Departure from Parking & Loading Standards DPLS-431
Departure from Design Standards DDS-635

Application	General Data	
<p>Project Name: Dollar General – Livingston Road</p> <p>Location: East side of Livingston Road, approximately 125 feet north of its intersection with Saint Barnabas Road (MD 414).</p> <p>Applicant/Address: Pace Livingston, LLC. 9171 Central Avenue, Suite 345 Capitol Heights, MD 20743</p> <p>Property Owner: NSR Petro Services 7303 Hanover Parkway, Suite A Greenbelt, MD 20770</p>	Planning Board Hearing Date:	01/05/17
	Staff Report Date:	12/21/16
	Date Accepted:	09/15/16
	Planning Board Action Limit:	N/A
	Plan Acreage:	0.84 acres
	Zone:	C-S-C
	Gross Floor Area:	7,545 sq. ft.
	Lots:	N/A
	Parcels:	1
	Planning Area:	76B
	Council District:	08
	Election District:	12
	Municipality:	N/A
200-Scale Base Map:	209SE02

TECHNICAL STAFF REPORT

SUBJECT: **Departure from Parking and Loading Standards Application No. DPLS-431**
Departure from Design Standards Application No. DDS-635

LANDSCAPE PLAN

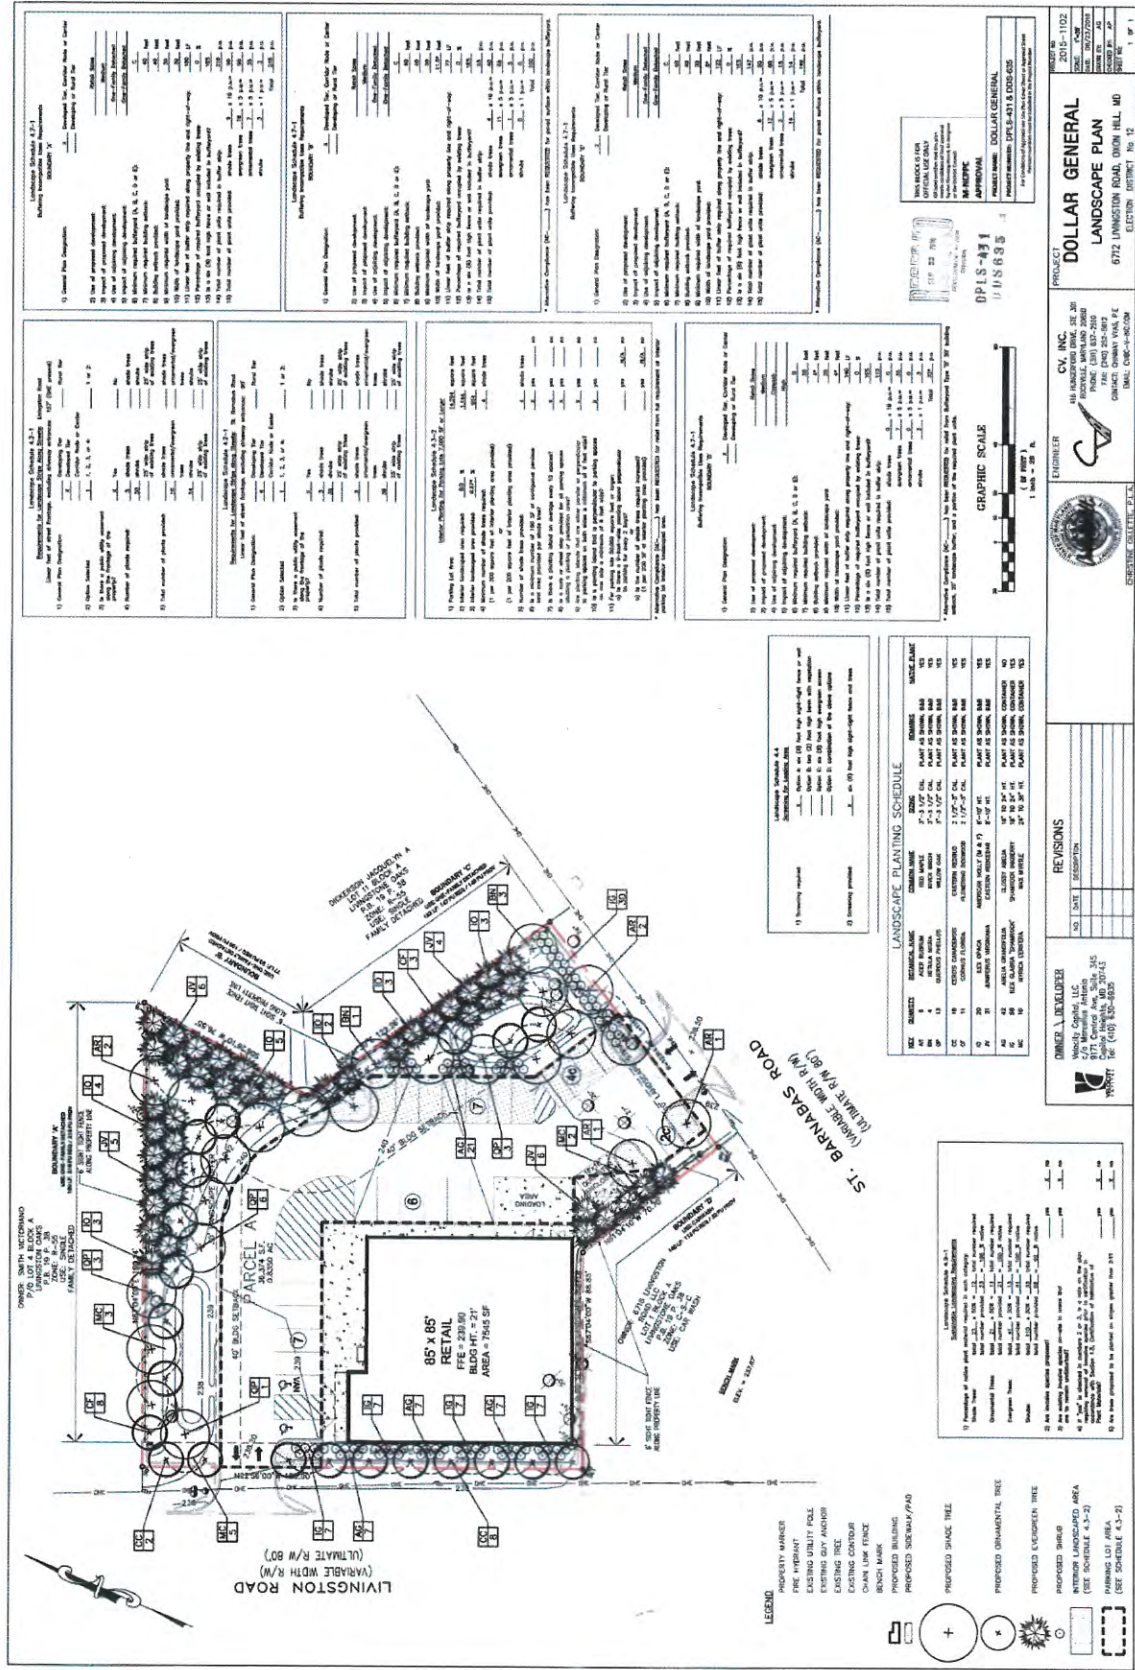
Whereas a landscaped area of eight percent and a planting island on average for every 10 spaces is required for parking lots over 7,000 square feet in size, the applicant seeks relief by providing 6.67 percent of the requirement and larger shade trees (3-3 1/2" caliper) than normally required. Although the schedule indicates four shade trees are provided as required, it appears that only two are actually provided within the interior parking area. However, shade trees are proposed at the perimeter of the parking compound which will provide shade for a portion of a parking area. In addition, the Committee finds that if a planting box, with either two shade trees or ornamental trees, is provided in the paved area in front of the store where it is approximately 18 feet wide, then the proposal would be acceptable.

The Committee also finds any future landscape plan submittals should include the following revisions:

- Provide a planting box, with either two shade trees or low growing evergreens, in the paved area in front of the store.
- Expand Bufferyard B area along the drive aisle to include additional plantings.
